Pedestrian & Bicycle Consideration Review

City of Pembroke, KY Pembroke Connector Route

Bicycle and Pedestrian Review for District 2 Pembroke Connector Route

(Figure 1) / KYTC Photo Van View /

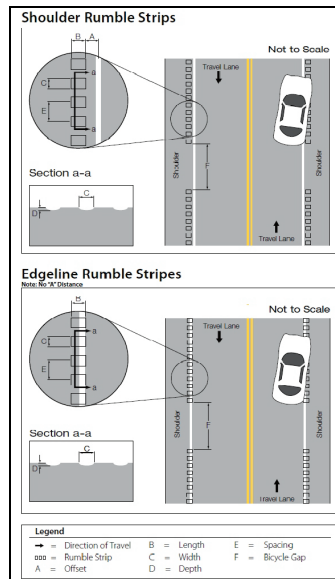
- US-41 / MP 3-4
 - ADT is 6075
 - Posted speed limit is 55 MPH (MP 3.34-4.0) / 45 MPH (MP 3.16-3.344)
 - Paved shoulder width is less than 4 feet
 - Rural cross section design
 - The Bicycle Comfort Index (BCI) average rating is a level D
- KY-115 / MP 9.5-9.9
 - ADT is 2030
 - Posted speed limit is 45 MPH (MP 9.82-9.907) / 55 MPH (MP 9.5-9.82)
 - No paved shoulder
 - Rural cross section design
 - Narrow bridge at MP 9.905-9.918
 - Route used by and signed for horse and buggies use (Figure 1)
 - School located at MP 9.106
 - The Bicycle Comfort Index (BCI) average rating is a level C
